# 1966 Corvette: Service Bulletin: Automatic Choke Malfunction

**Subject:** Automatic Choke Malfunction

**Bulletin No:** TSB #66-6, DR #66-6

**Date:** November 18, 1965

FIG. I - CHOKE THERMOSTAT ASSEMBLY - 283 V-8

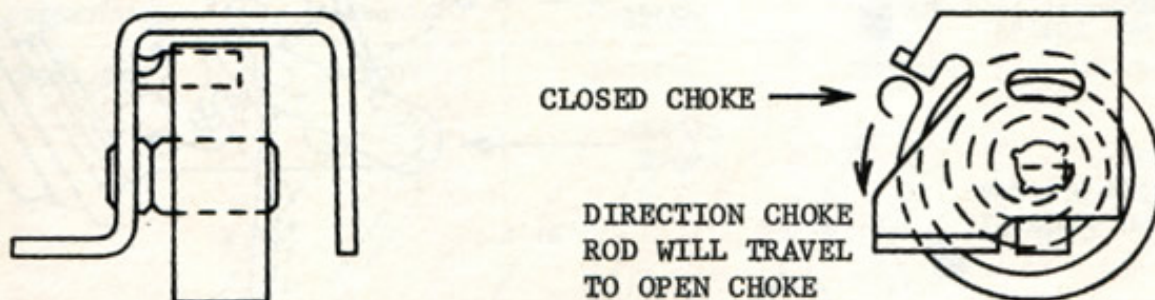
NOTE: Choke thermostat assemblies, although similar in appearance, are not interchangeable. Check bracket design as shown in Figures I, II and III and the coil spring identification number shown on chart (Number stamped in coil, not number in ink). Choke coil springs are indexed to bracket and must not be interchanged or repositioned.

FIG. II - CHOKE THERMOSTAT ASSEMBLY - 327 V-8 (275 HP)

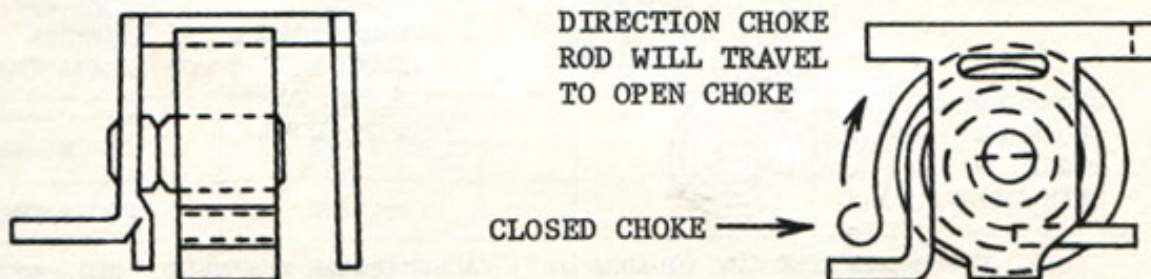
It should be noted that an important difference exists between the 327" (275 h.p.) engine choke operation and the remaining V-8 engines. That is, the direction of the thermostat operation between the two units is reversed. On the 327" (275 h.p.) application, the eye of the thermostat coil and the corresponding choke rod travels from a down position for closed choke relaxing upward for open choke. On the remaining V-8 engines (except 283 4

FIG. IV - ROCHESTER 4MV (QUADRA JET) VACUUM BREAK ASSEMBLY

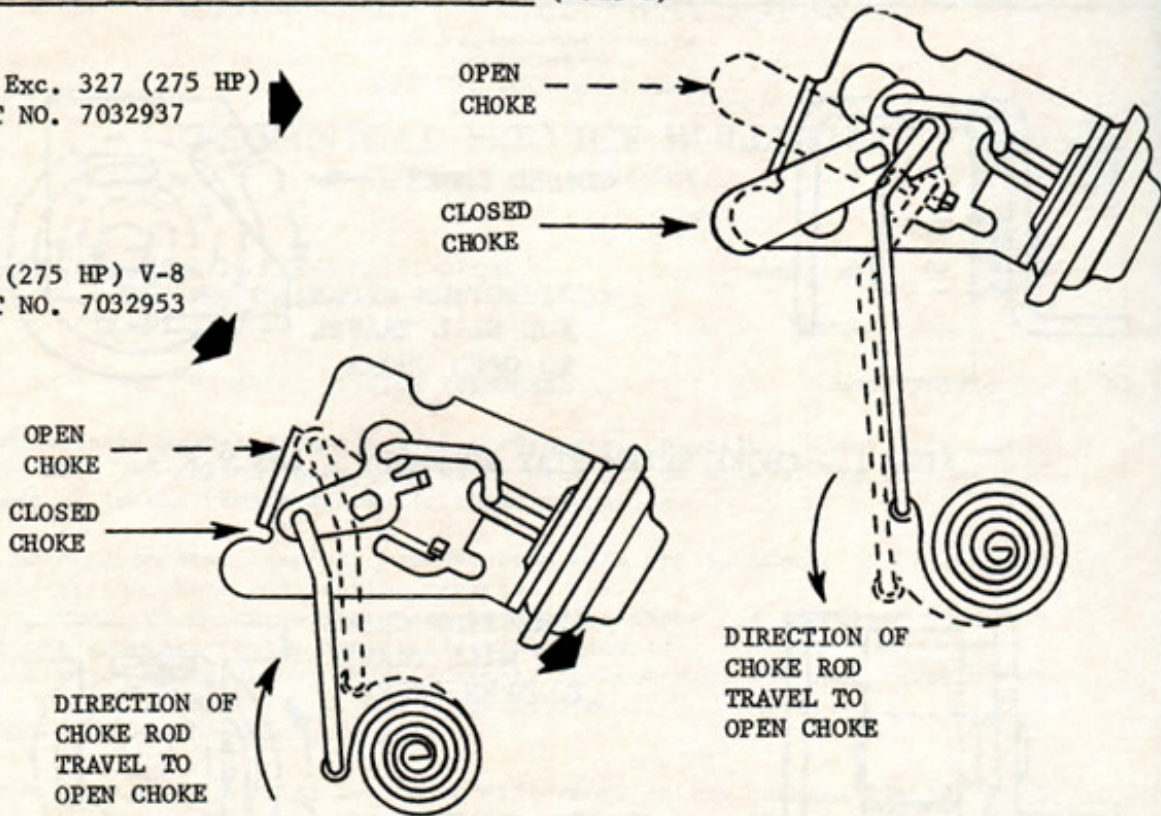
1. Choke thermostat assembly manufactured with the incorrect choke coil spring and/or the choke coil spring reversed.
2. Incorrect choke thermostat assembly and/or choke rod installed.
3. Choke rod incorrectly installed (upside down).
4. Incorrect choke vacuum break assembly on Rochester 4MV carburetor (Quadrajete).
5. Incorrect choke lever on Holley carburetor.
6. Incorrect carburetor on engine.

V-8 Exc. 327 (275 HP)  
PART NO. 7032937

327 (275 HP) V-8  
PART NO. 7032953

**ROCHESTER 4MV (QUADRAJET) VACUUM BREAK ASSEMBLY REPLACEMENT**

1. Remove carburetor air horn as outlined on Page 6M-25 of the 1966 Chassis Overhaul Manual.
2. Remove retaining screw from choke vacuum break assembly, then remove assembly.
3. Remove choke lever from float bowl well.
4. Install choke vacuum break assembly as outlined on Page 6M-27, Steps 5, 6, and 7 of the 1966 Chassis Overhaul Manual.
5. Install carburetor air horn as outlined on Page 6M-29 of the 1966 Chassis Overhaul Manual.

FIG. V - HOLLEY CHOKE LEVER AND VACUUM BREAK ASSEMBLY

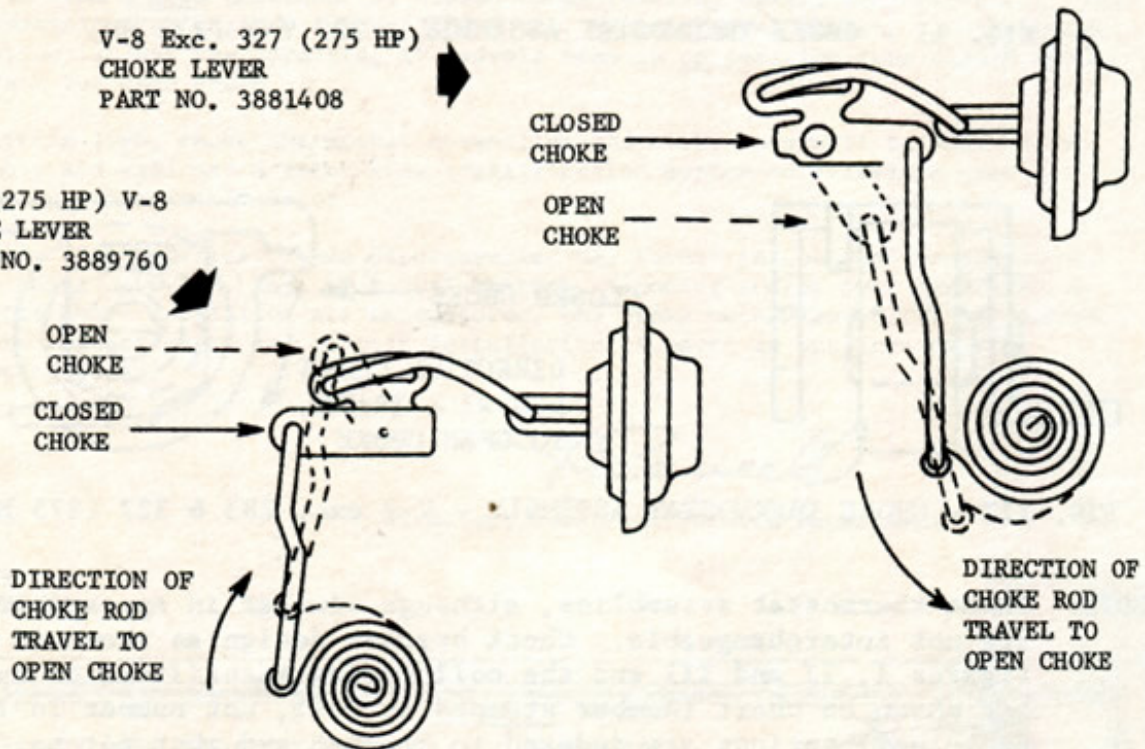
V-8 Exc. 327 (275 HP)  
CHOKE LEVER  
PART NO. 3881408

327 (275 HP) V-8  
CHOKE LEVER  
PART NO. 3889760

**HOLLEY CHOKE LEVER REPLACEMENT**

Disconnect choke vacuum break link, then remove choke lever retainer and choke lever. Reverse procedure to replace.
